MEMORANDUM

TO: District of Columbia Zoning Commission

DATE: September 4, 2026

SUBJECT: OP Public Hearing Report for Zoning Commission #26-07, Design Review in the Northern Howard Road (NHR) Zone

Attachment 3 Office of Planning Neighborhood Planning Division Comments

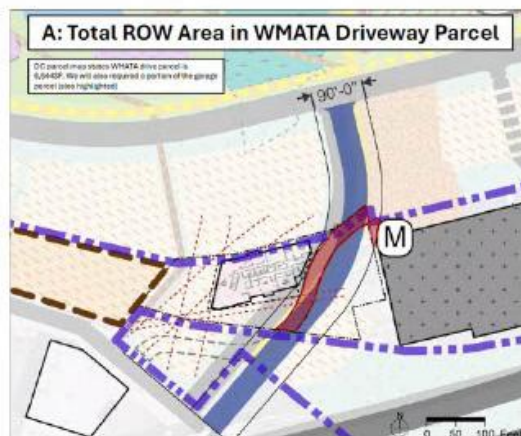
Thank you for sharing the design review application with Neighborhood Planning and bringing this to my attention. As the Poplar Point Master Plan project manager, I find this application significantly lacking and non-reflective of the conversations that OP and DMPED have had with Redbrick. I've included a snip from an illustrative diagram that the District and Redbrick discussed as a solution for alignment (note: existing WMATA road highlighted in red, Draft Land Use Plan right-of-way shown in gray, and shifted planned road that accommodates Redbrick development while continuing to make the Poplar Point development feasible shown in blue):

Accordingly, my main concern is that the current development is designed such that it completely turns its back on Poplar Point and can obstruct ongoing plans for Poplar Point, a project that Redbrick has been a stakeholder in since its initial stages. It fails to factor in the draft land use plan shared with Redbrick and the public as part of the Poplar Point Plan's Environmental Assessment process led by the District and NPS.

While the submitted language refers to the benefit of development for the future Poplar Point development and alignment with the Comprehensive Plan's Urban Design Element, it does not show good urban design along the WMATA roadway, where a key gateway into Poplar Point and equity-driven major connection with the historic Anacostia neighborhood is planned. Applicant mentions a green screen and mural in exhibit 15, which Neighborhood Planning can support but find insufficient as a

standalone solution to contribute to the active pedestrian-priority environment outlined in plans for Poplar Point - especially with the back of house, blank walls, and service area positioned directly across the street from the planned center of activity, community plaza and major gateway for Poplar Point. It is also worth noting that the development is positioned around the corner from the main planned mixed-use street and East-West connection to the north of the Redbrick development (the relocated Anacostia Drive), though it does not immediately abut it.

Though it is understandable that plans are based on existing conditions, the applicant should submit an additional memo recognizing and accurately representing the stakeholder conversations DMPED and OP have had with Redbrick and their design team to reach a design that would be supportive and non-restrictive of the ongoing planning effort for Poplar Point, as well as a plan and elevation/other supporting graphic(s) showing:

- how building positioning and street wall will interface with the planned public space and streetscape at Poplar Point, by including, particularly on the eastern edge facing the planned metro civic plaza and major connector street:

- an engaging façade with a play in materials and active building projections that accommodate people and blur the private-public space divide (balconies, show windows, bay windows, etc.);

- high visibility glass and frequent entry points into the hotel;
 - at least a 10' wide tenant zone that can accommodate planted areas and sidewalk seating between the building face and the sidewalk pedestrian clearance;
